STAFF DESIGN COMMISSION REPORT

Project Name: Kensington School
Project Address: 840 E. Kensington Road
Prepared By: Steve Hautzinger

DC Number: 16-031
Petitioner Name: Charles Marlas
Petitioner Address: Kensington School
743 McClintock Drive
Burr Ridge, IL 60527
Meeting Date: April 26, 2016

1. Approval of the proposed architectural design for a new preschool / children's day care center.

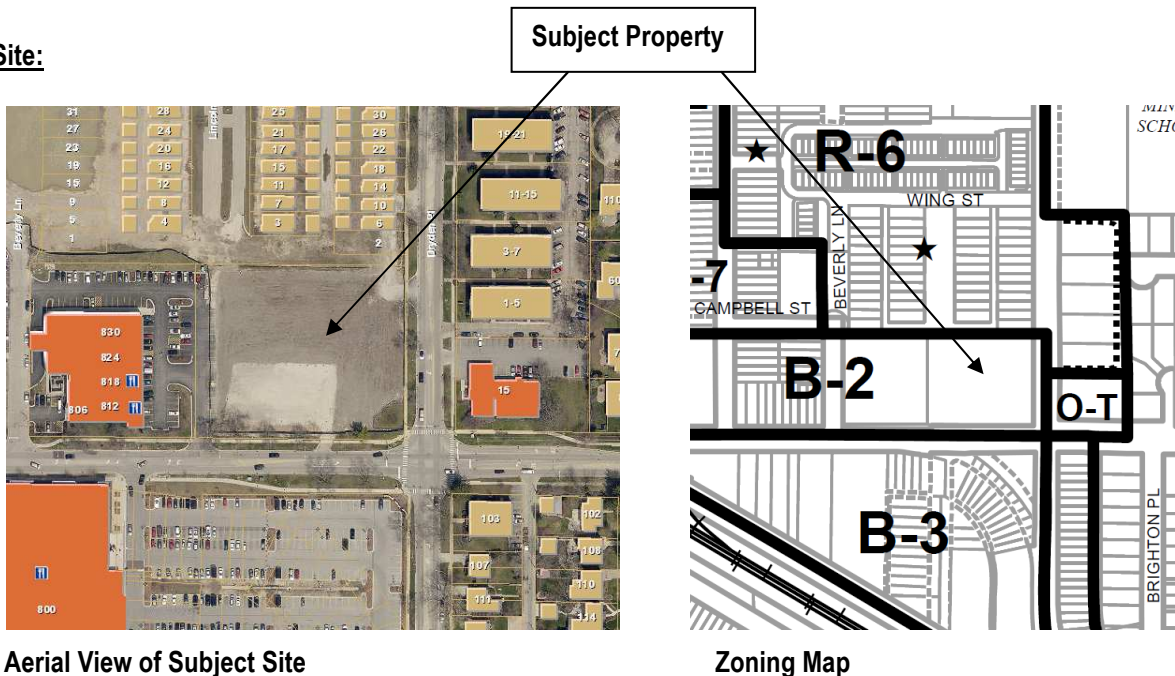
The proposed design has a traditional appearance and colonial style with red brick, black roof, white windows, white trim, and a white picket fence. The style of this building could fit beautifully in, or adjacent to, a traditional single family neighborhood. However, in this location, the proposed design looks out of place with the surrounding commercial context.

The proposed design is a prototype building that was not specifically designed to fit in this location, and it does not comply with the requirements of the Hickory Kensington Design Guidelines. The design needs to be revised to have a more modern aesthetic and material palette to complement the adjacent retail buildings. For a more cohesive development, it is recommended that the design be revised to better complement the existing multi-tenant retail building to the west (shown in Images 1 & 2 below).

1. Change the asphalt shingle roof to a green standing seam metal roof to match the adjacent retail building.
2. Change the white trim and white windows to darker colors for a less colonial appearance and to better complement the adjacent retail building.
3. Continue the brick up into the gables.
4. Add fabric awnings above the windows.

1. **Building Architecture.** Per the Hickory Kensington Design Guidelines, the proposed design needs to be revised to complement the adjacent retail buildings. Options to consider include:

- a. Change the asphalt shingle roof to a green standing seam metal roof to match the adjacent retail building.
 - b. Change the white trim and white windows to darker colors for a less colonial appearance and to better complement the adjacent retail building.

- c. Continue the brick up into the gables.
 - d. Add fabric awnings above the windows.
2. **Landscaped Plaza.** Re-introduce a landscaped pedestrian plaza within the 25' x 144' pedestrian access easement at the northwest corner of the site.

EXHIBIT A – Approved PUD Site Plan and Landscaped Plaza

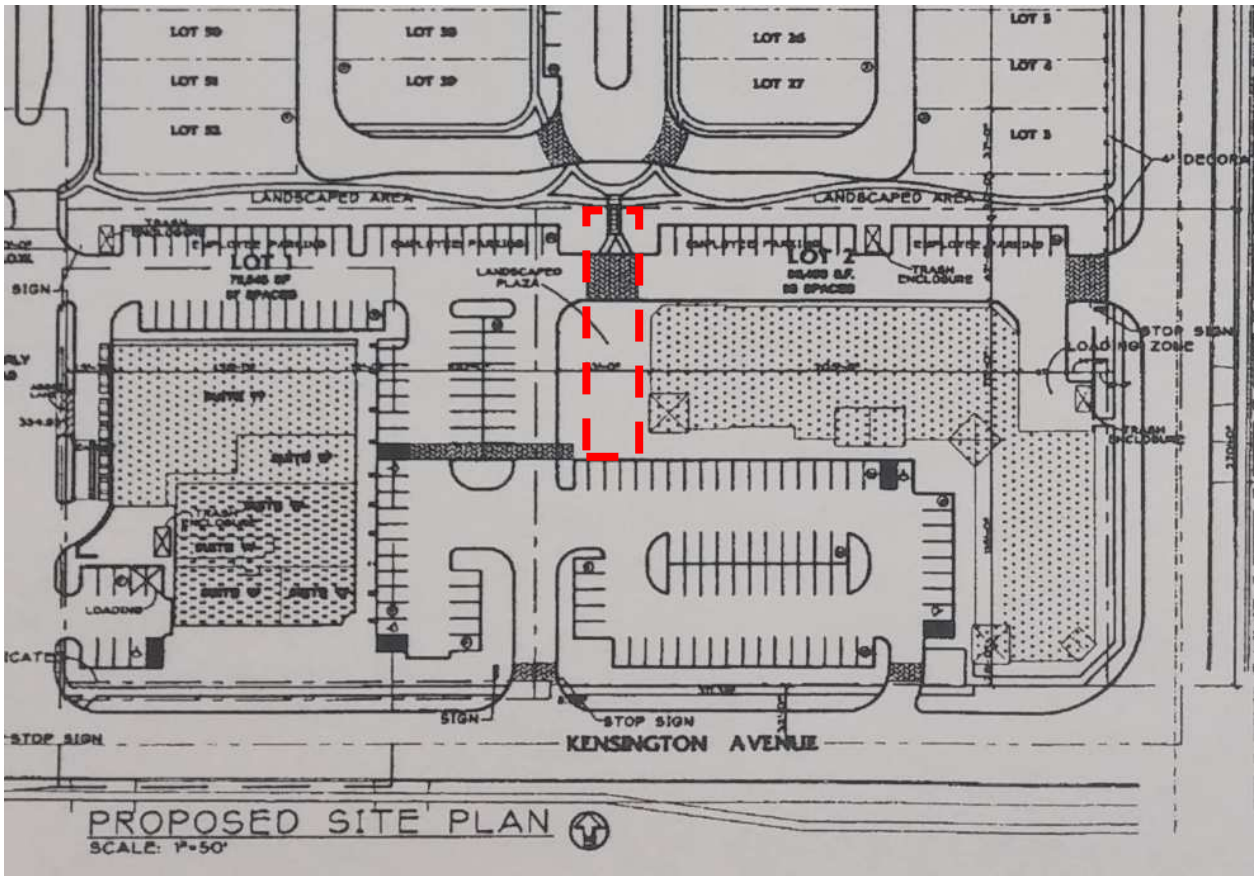
Additionally, in 2006, the Design Commission approved a retail building for this site that was designed with the same architectural details as the existing adjacent multi-tenant retail building. A corner element facing the street intersection was one of the design elements encouraged by the Design Commission, and a pedestrian plaza connection from the residences to the north was required as shown in Exhibit A.

- 1. Landscaped Plaza.** The original PUD approval included a landscaped pedestrian plaza at the northwest corner of this site to connect the commercial properties to the residential neighborhood to the north. To accommodate this plaza, the Plat of Subdivision includes a 25 foot wide pedestrian access easement which is setback 31 feet from the west property line, and runs 144 feet north to south from the north property line (refer to Exhibit A). This feature is a significant component of the overall master plan for the Arlington Market development, and the Kensington School site design needs to be revised to include it as a focal point for the retail, residential, and subject property.
